Bulletin No. 2003-03

Drum Coupling Wire Contact - Tour Edition SE motors

TR109P FB, TR109 FB, TR82P FB, TR82 FB

ob00771

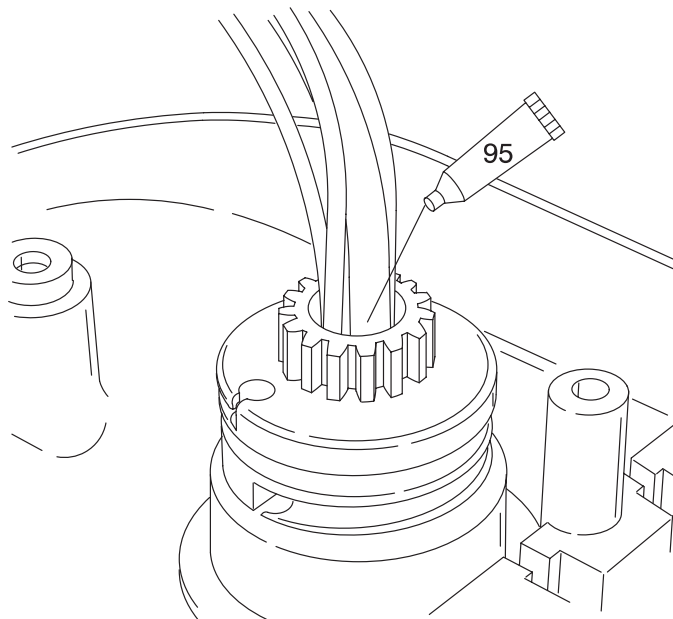
The low current wires on Smart Electronic units may show signs of abrasion due to contact inside the drum control coupling located in the head unit.

In the control housing, remove the cable retainer. Lift the cable assembly off of the drum control coupling. Using a small brush, liberally apply lithium-based grease to the wires extending from the column. The grease application should extend ½" above and ½" below the bottom of the coupling. Reinstall the drum controller over the drum control coupling and secure the cables with the cable retainer.
